Open Issues on GV Models for DPPS

Identified issues

Justification of plausibility check impactor simulation

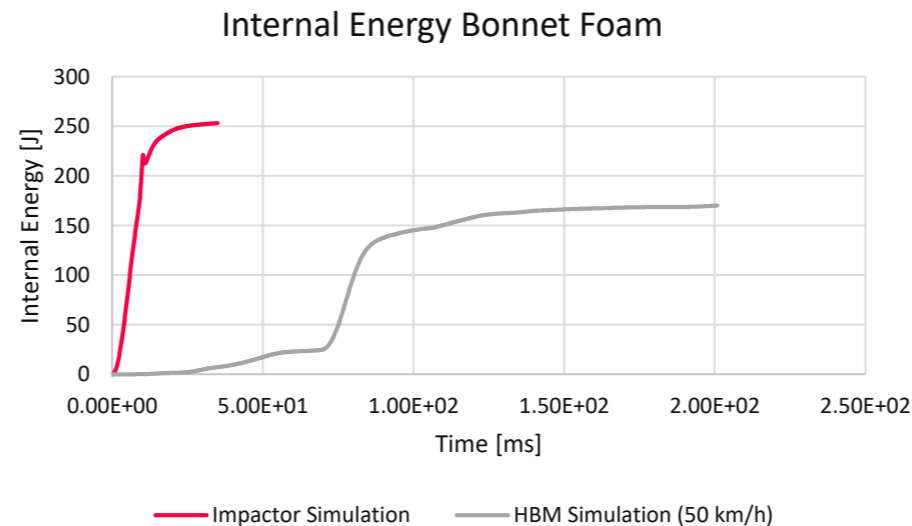
- Internal energy comparison between full HBM Simulation (FCR, 50 km/h, AM50 HBM) and Impactor Simulation for bonnet:
 - In HBM Simulation: 70% of the internal energy of the impactor simulation for bonnet foam

Justification of plausibility check impactor simulation

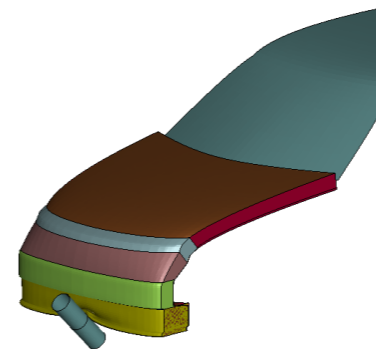
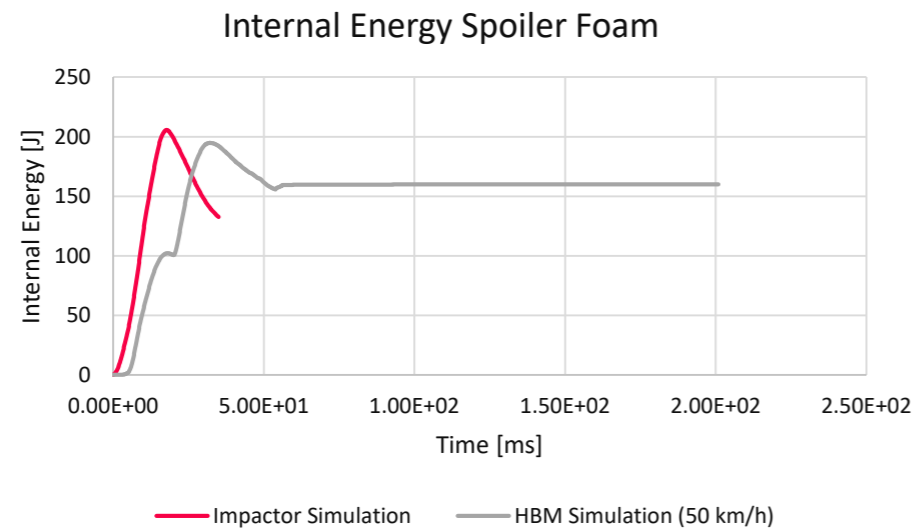
- Internal energy comparison between full HBM Simulation (FCR, 50 km/h, AM50 HBM) and Impactor Simulation for spoiler
 - In HBM Simulation: 95% of the internal energy of the impactor simulation for spoiler foam

Why is hard stop modelling for bonnet important?

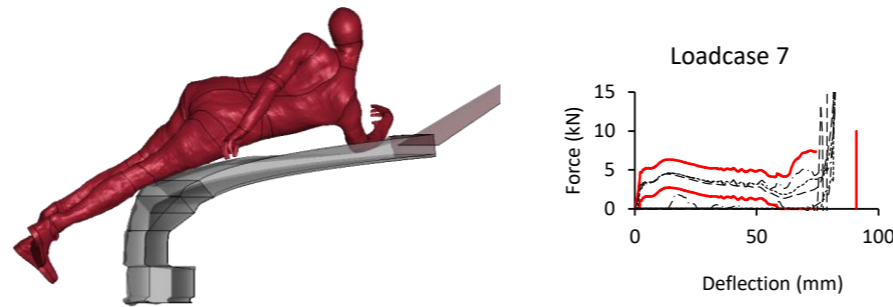
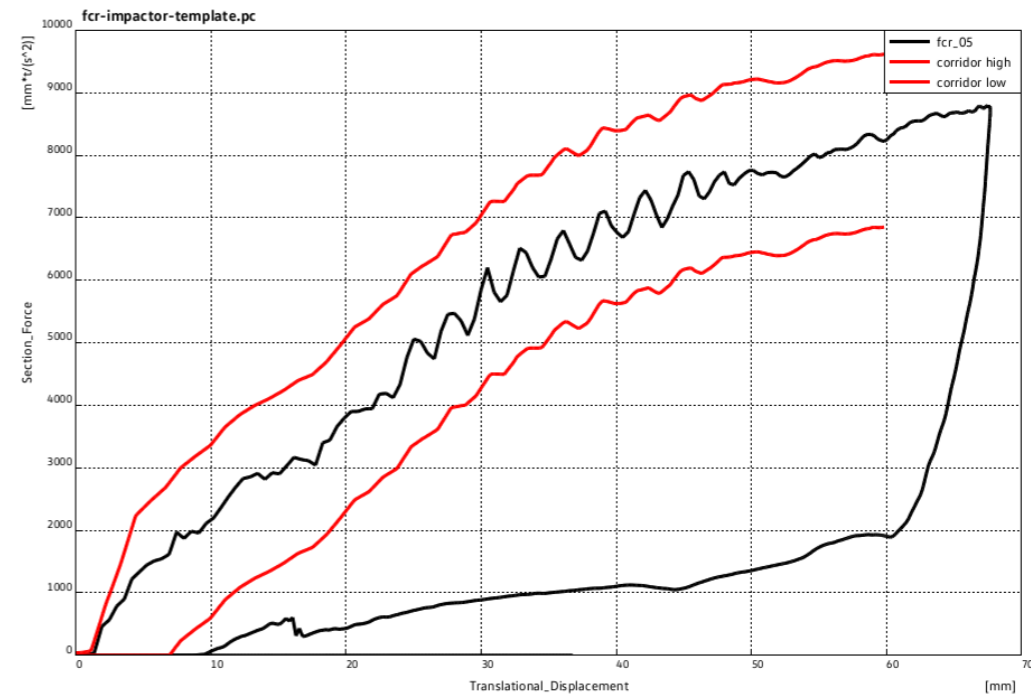
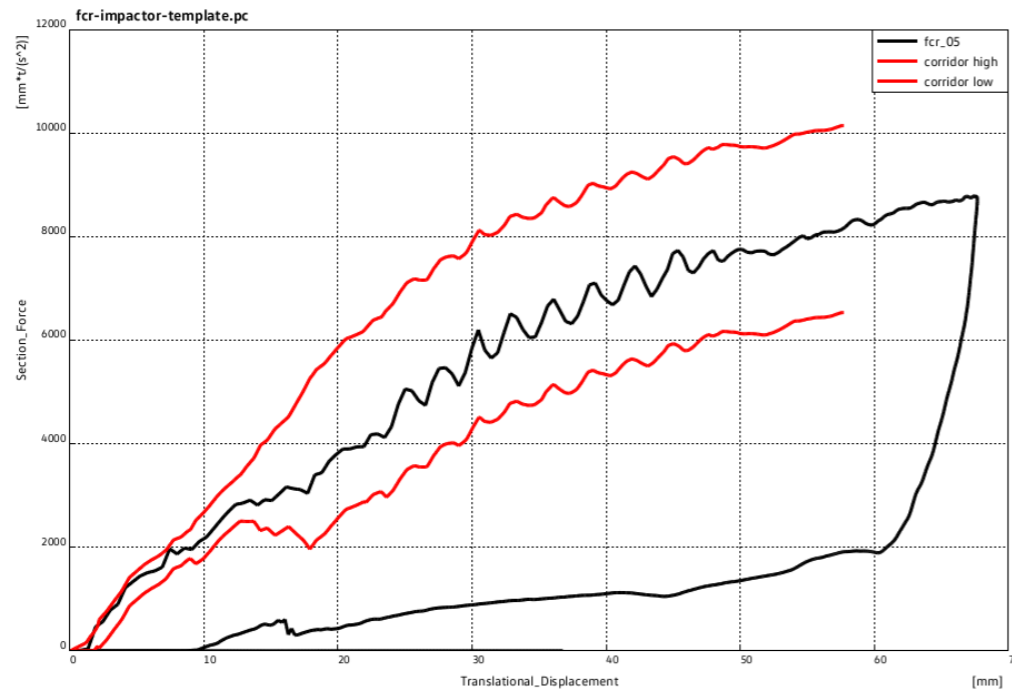
The hard stop (contact between interface and compaction layer) is intended to avoid instabilities in the bonnet foam caused by centered loads (for the shoulder / elbow)

Hard stops are also present in serial cars – maximum deflection is based on median maximum deflection derived from impactor simulations with full FE vehicle models

Draft Wording for MR1 (to be refined): „The steep increase of the force observe in Figure XX at XX mm deflection is caused by the modelling of the artificial hard stop due a contact between the interface and compaction layer at XX mm. To ensure that the GV models work robustly also in the most severe impact conditions (elbow impact on the bonnet), the rigid impactor simulations are performed with an Energy of ... J up to a hard stop. The hard stop is defined based on simulations with the same rigid impactor in full FE vehicle simulations.“

GV corridors

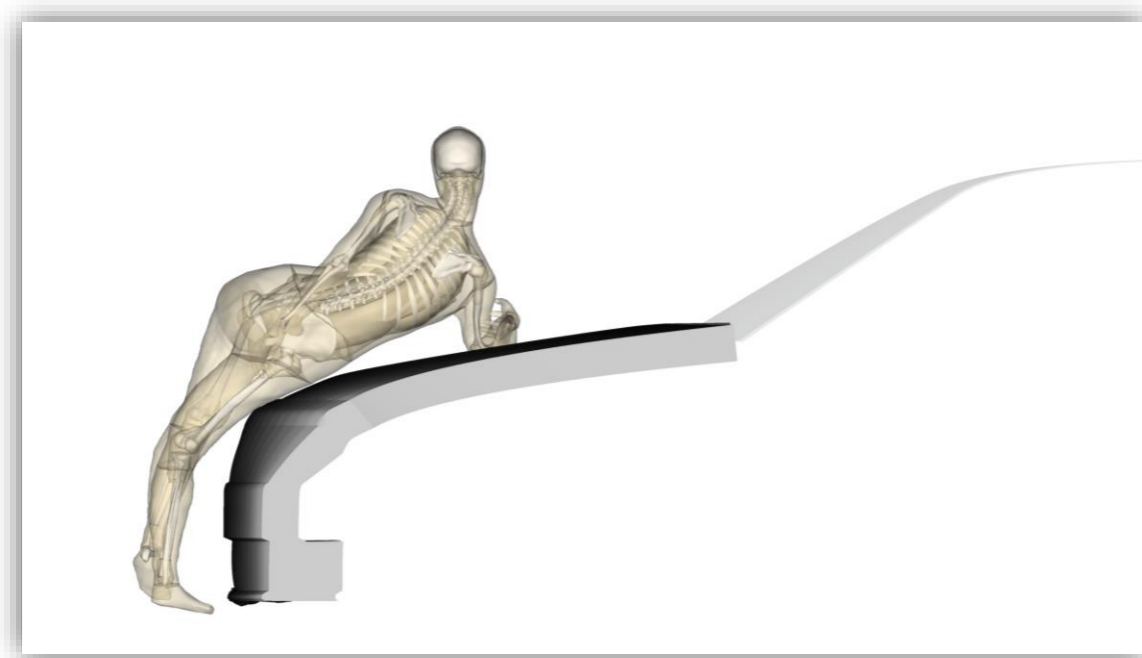
Old: originally curves have been moved to align them; now raw input data is used

Diagrams from check from one OEM

- Updated corridors – seems issue is solved; review by OEMs

(originally curves have been moved to align them – now raw input data is used; updated corridors will be uploaded to <https://openvt.eu/EuroNCAP/tb024/-/tree/GV-models-for-DPPS>)
